Access Compliance Report Public Rights-of-Way (Curb Ramps)

Main Street: PERCHERON_DR Cross Street: SYLVANOAK_WAY Location: NW

ADA ID: RPRK211112145619 Ramp Type: Type 4 - Parallel Initial Pass/Fail: Fail Overall Compliance: No Severity Score: 2

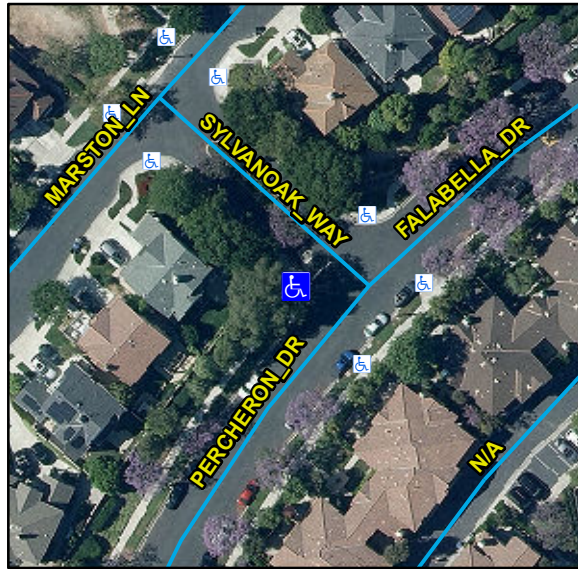
R304.2.2, R204.3, R304.5.3, STD 1115

Remove & Replace Curb Ramp With Two New Directional Ramps or Equivalent.
